# Addendum #1

Attn: Estimator	Date: February 21, 2024
From: Lisa Donahue, Project Administrator	Pages: 92 (including cover page)
Re: Bay City Public Schools	Project: 2024 SF BP 11 – Eastern HS at Handy MS
CC:	Proj. #: A23904

PROJECT TITLE  
 RENOVATION FOR BCPS:  
**BAY CITY EASTERN HIGH SCHOOL AT HANDY M.S.**

**16 FIRST FLOOR CONSTRUCTION PLAN - UNIT 'G'**  
SCALE: 1/8" = 1'-0"

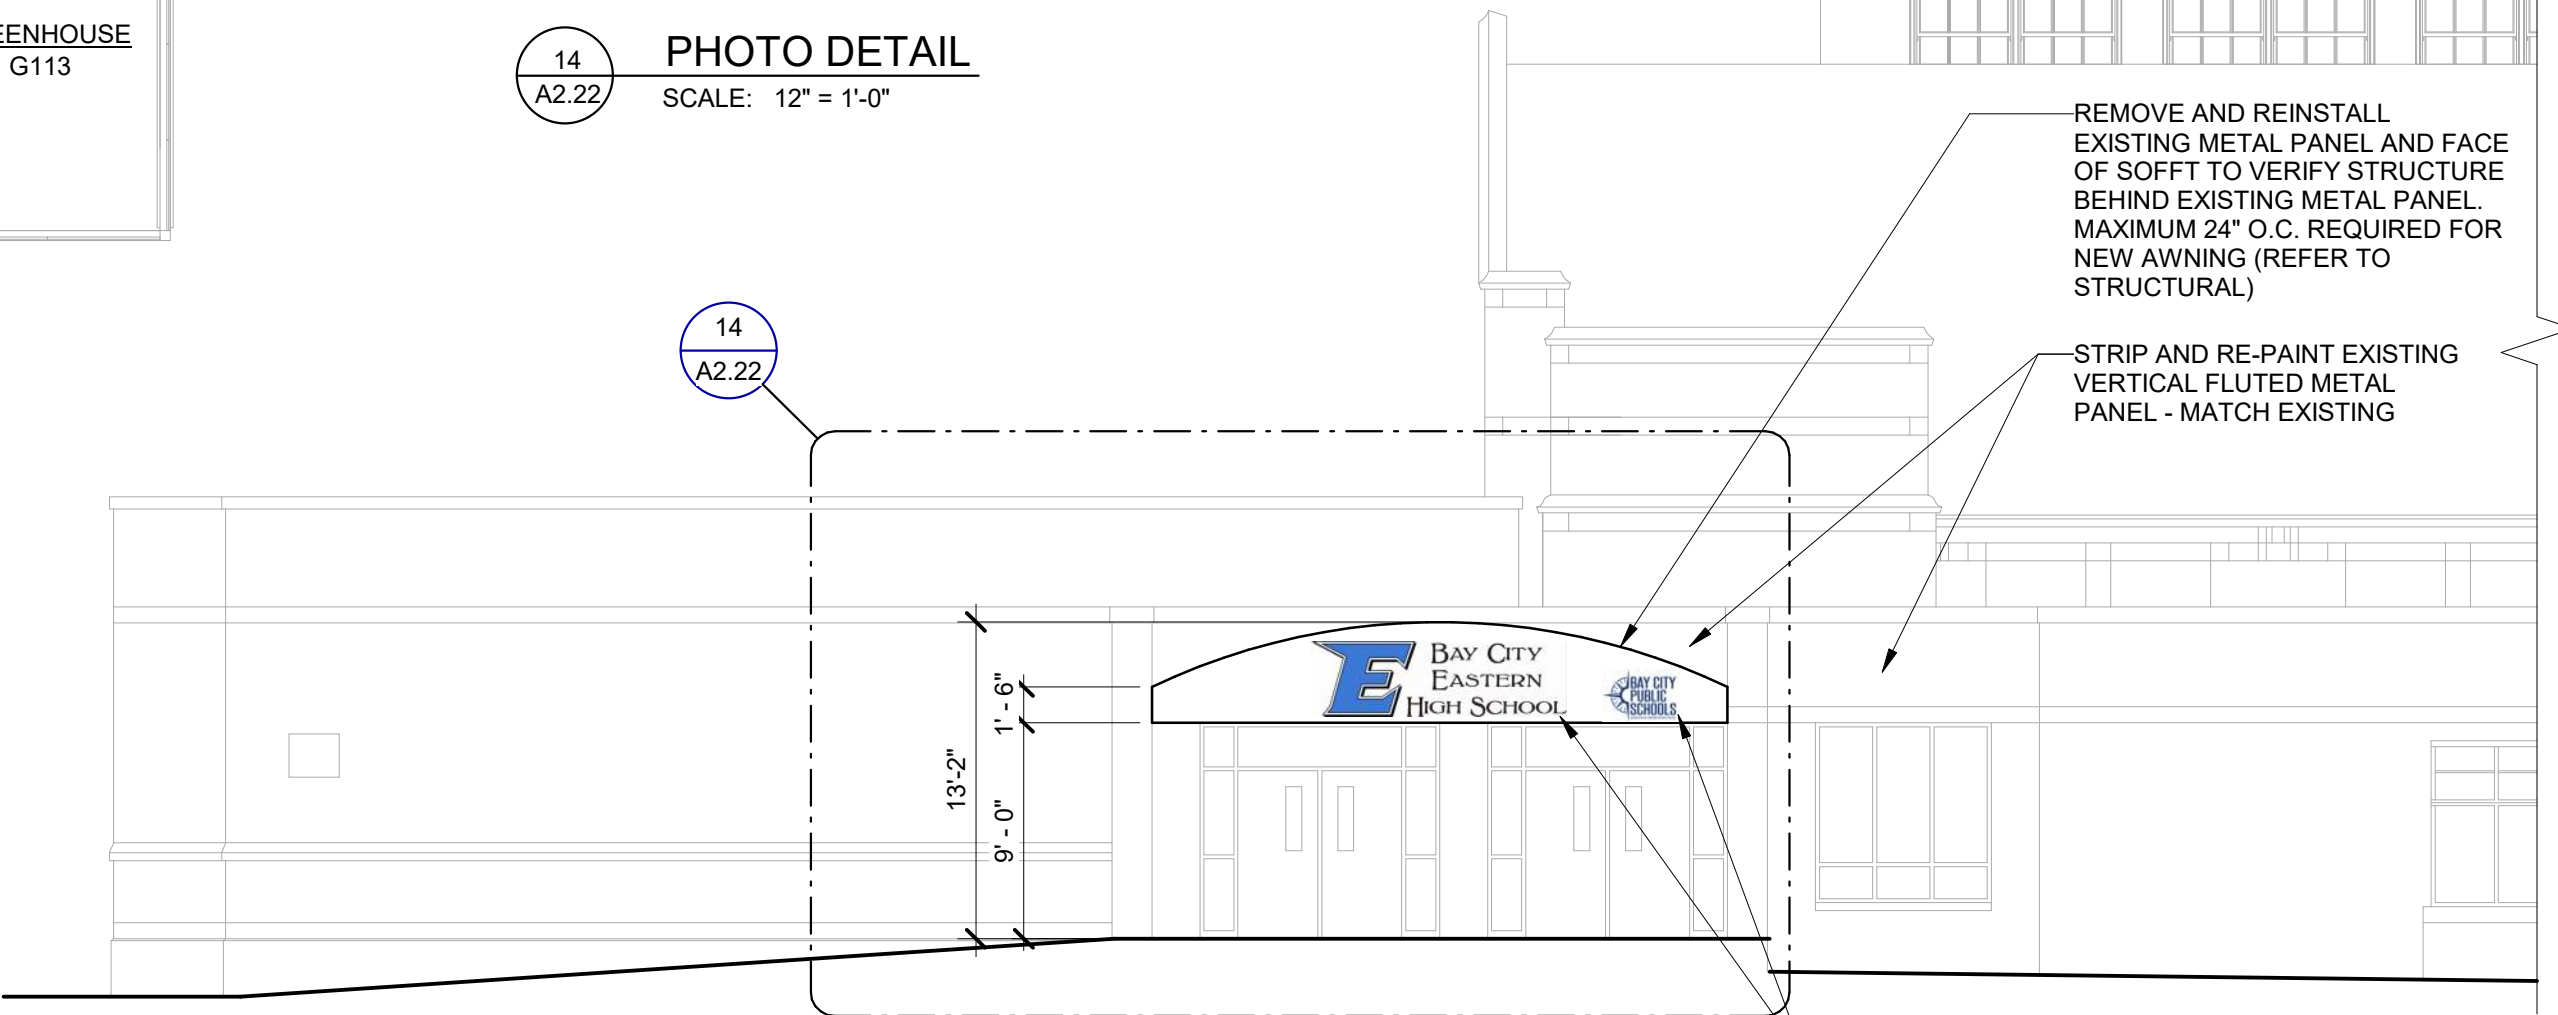
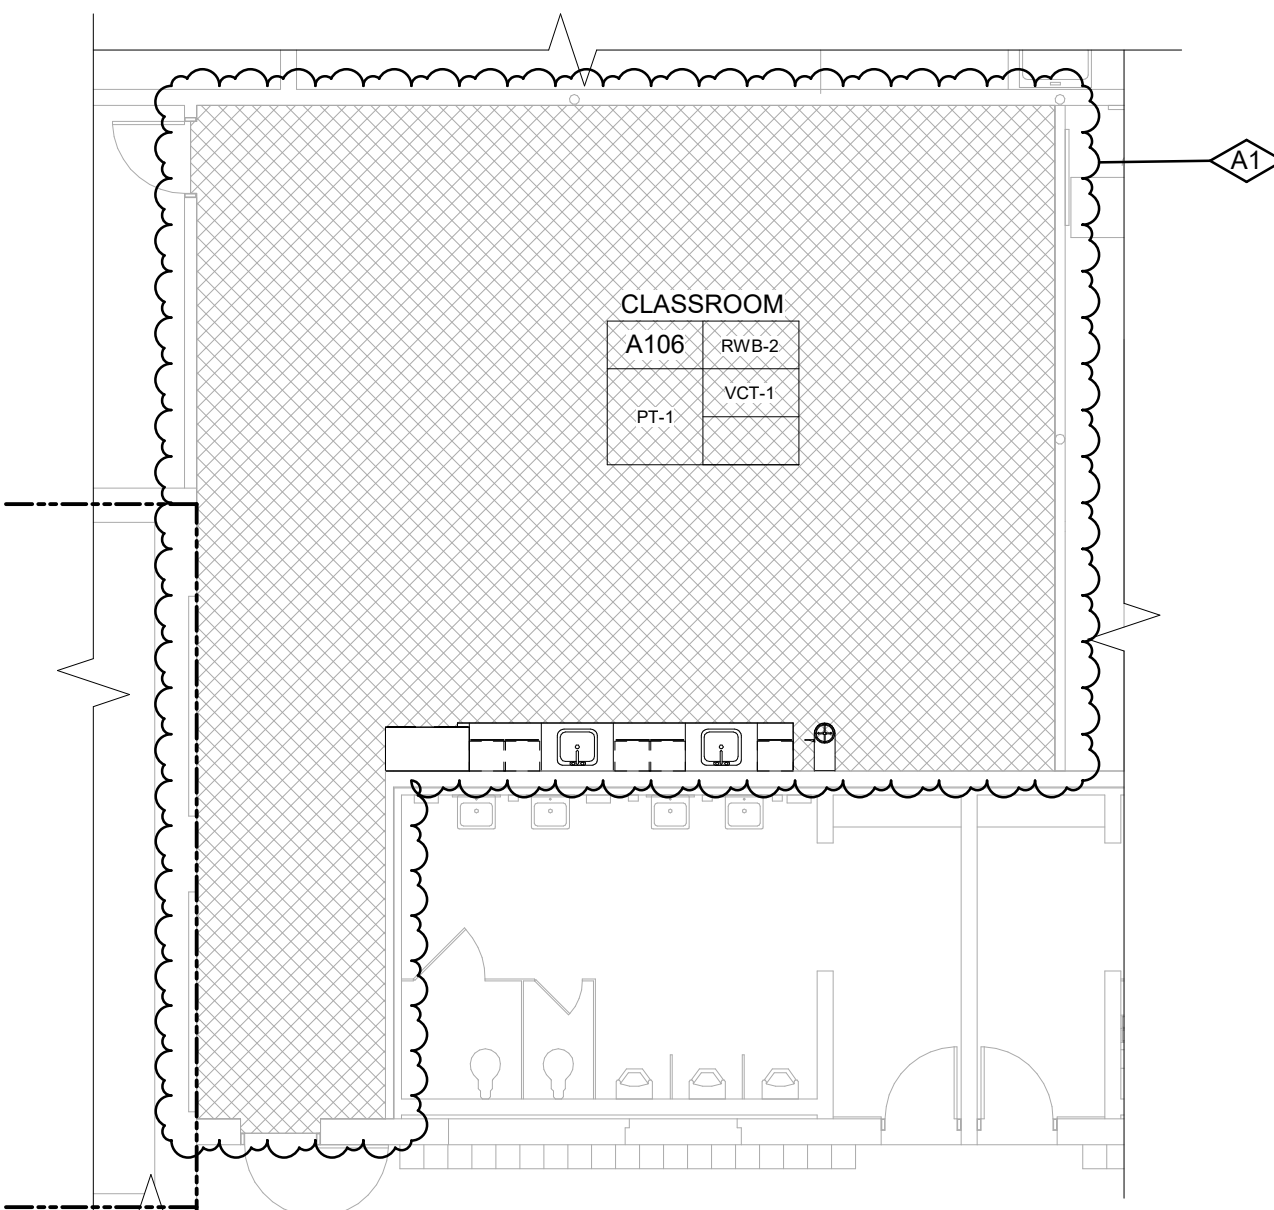
Item A9: Reference Sheet A2.22 (Re-Issued)

- A. Clarification: existing corridor width is 10'-0".
- B. Added keynote #28 to patch and repair concrete after station removal and cap existing plumbing.

PROJECT NUMBER <b>2018040.16</b>	SHEET NUMBER <b>A3.01</b>
PROJECT DATE FEBRUARY 1, 2024	
CHECKED BY J.A.R.

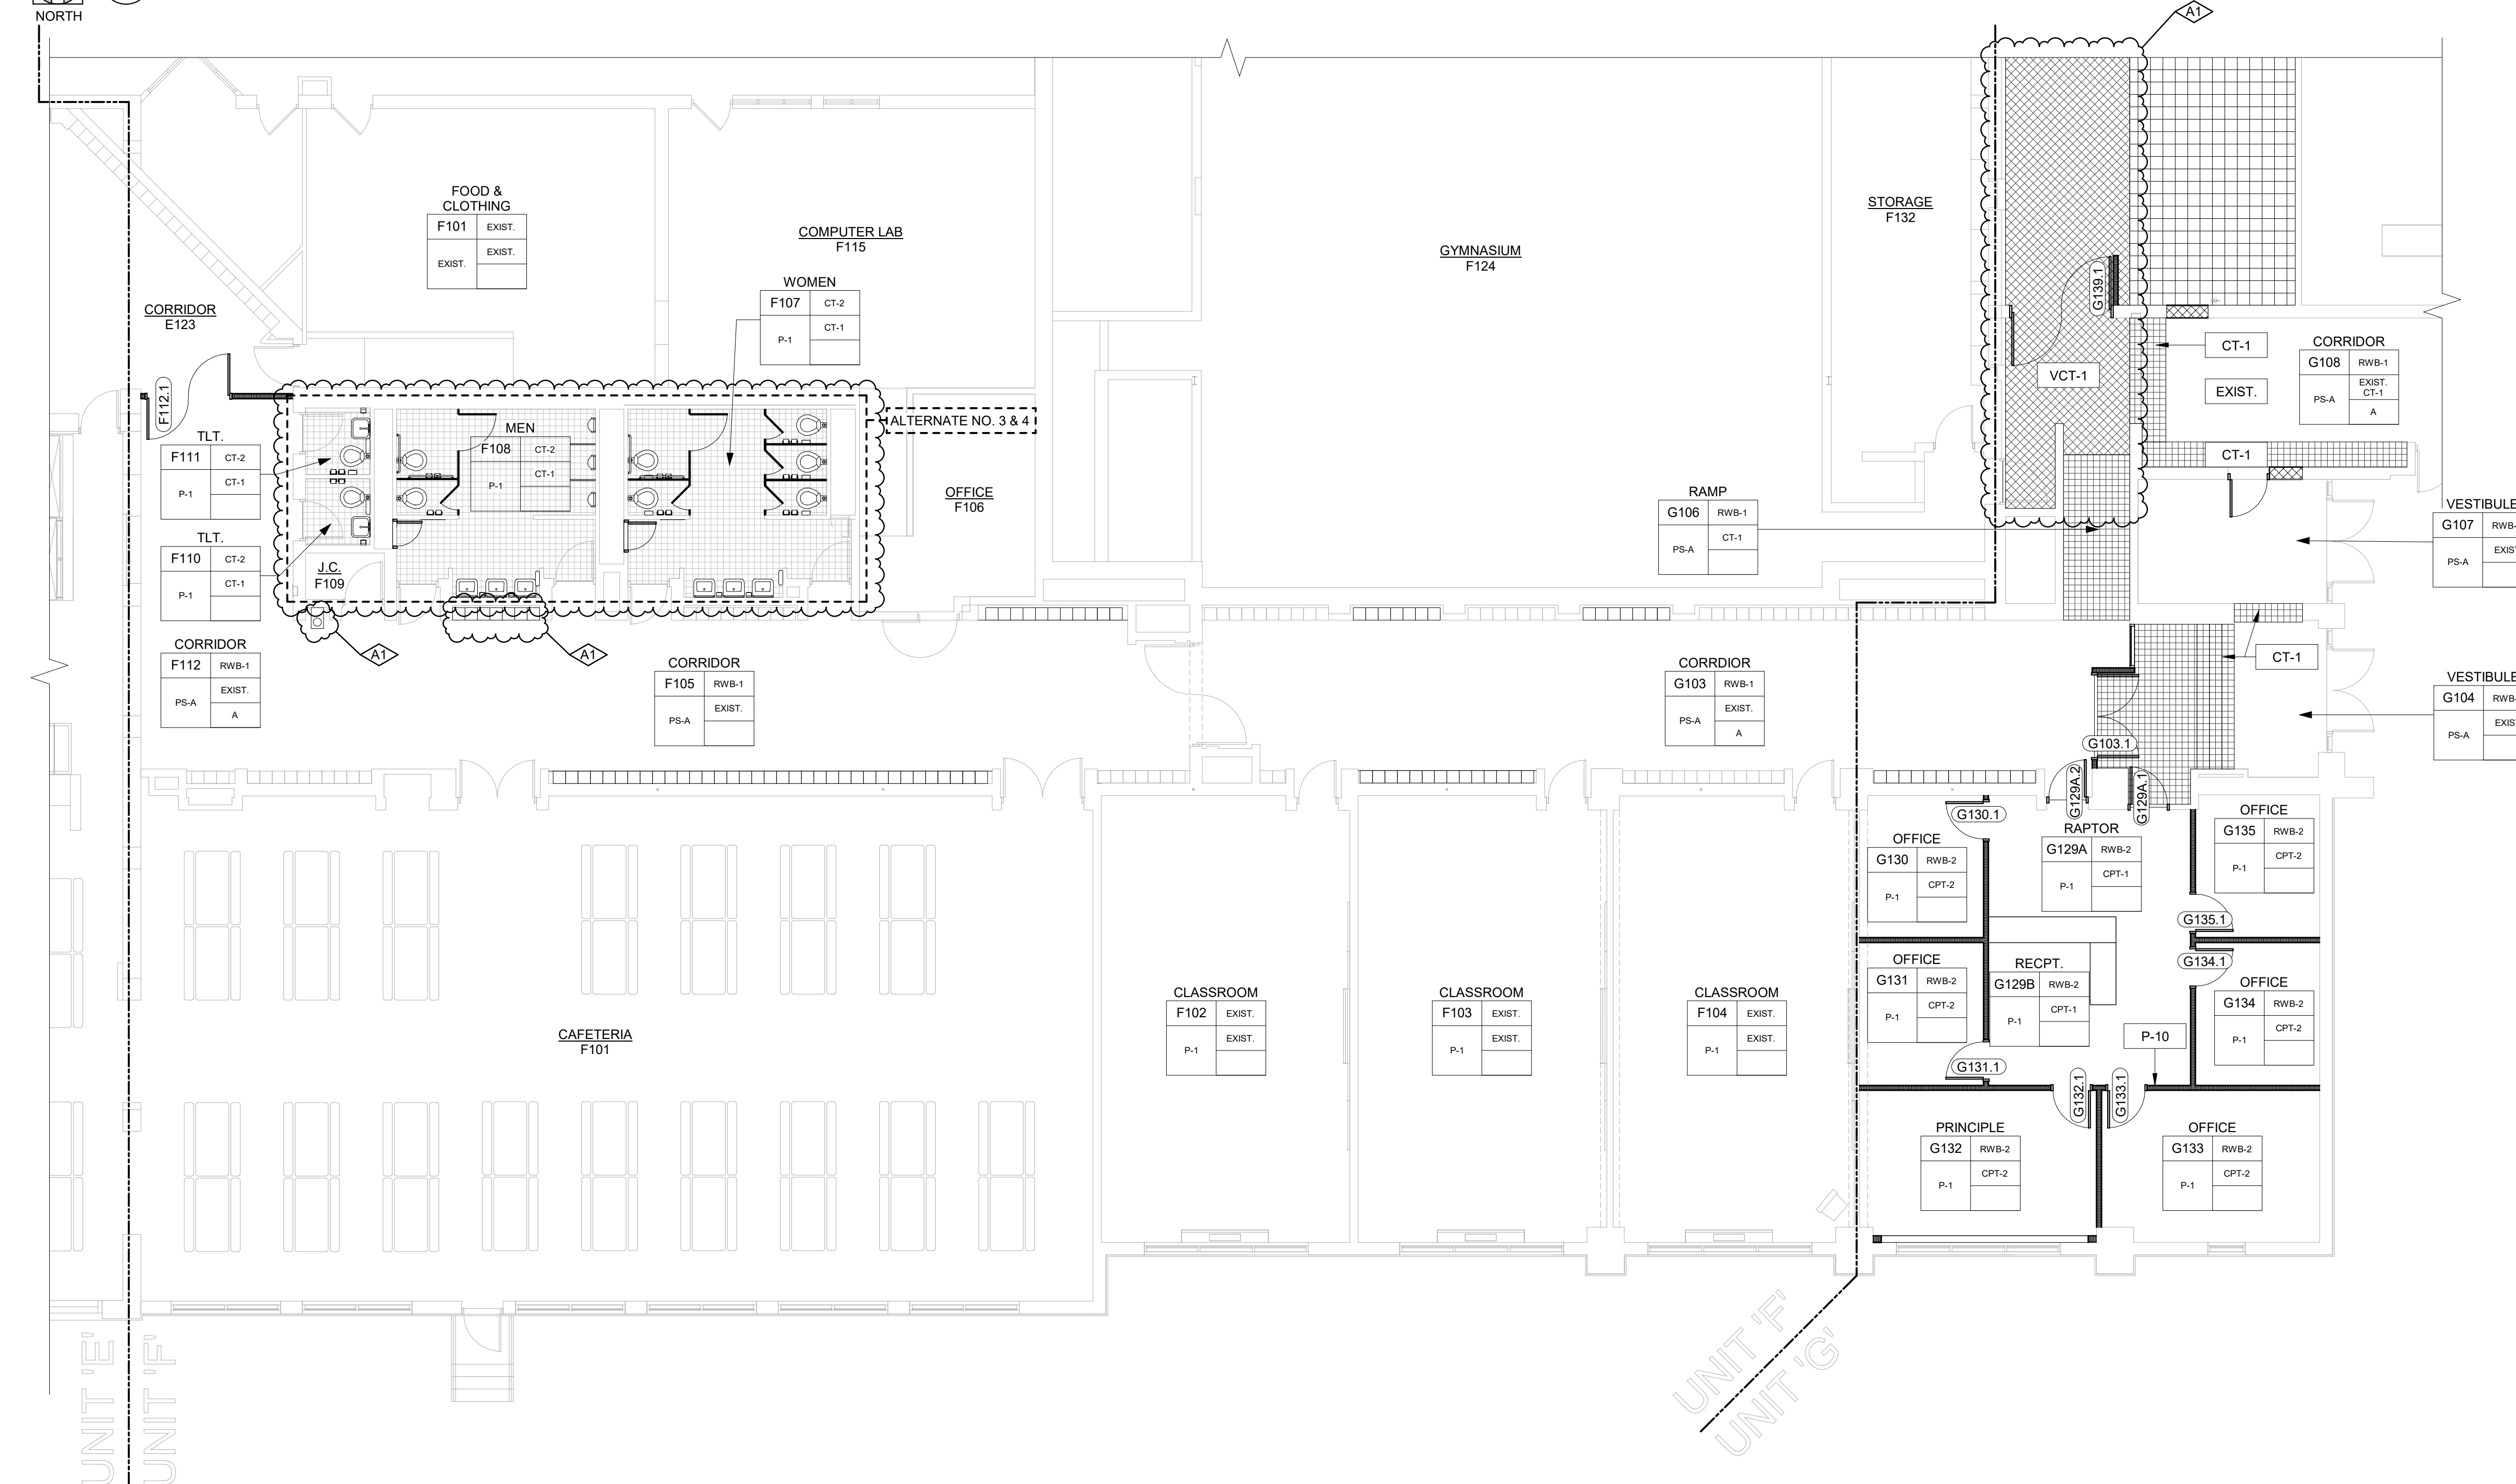
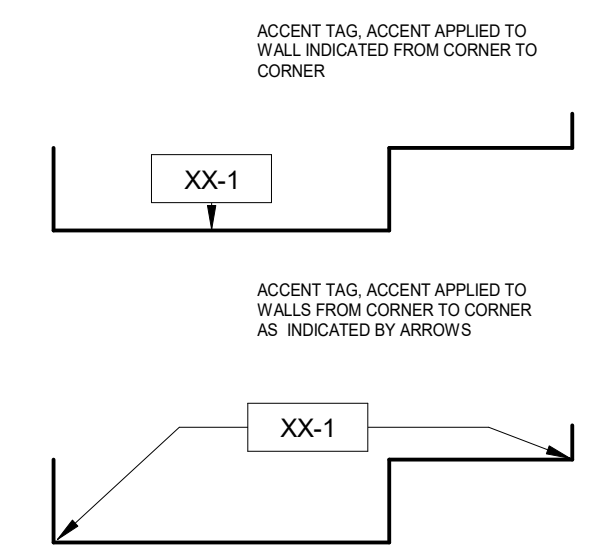
Item A10: Reference Sheet A3.01, A3.02 (Re-Issued)

- A. Added a hatch pattern to clarify floor material locations.
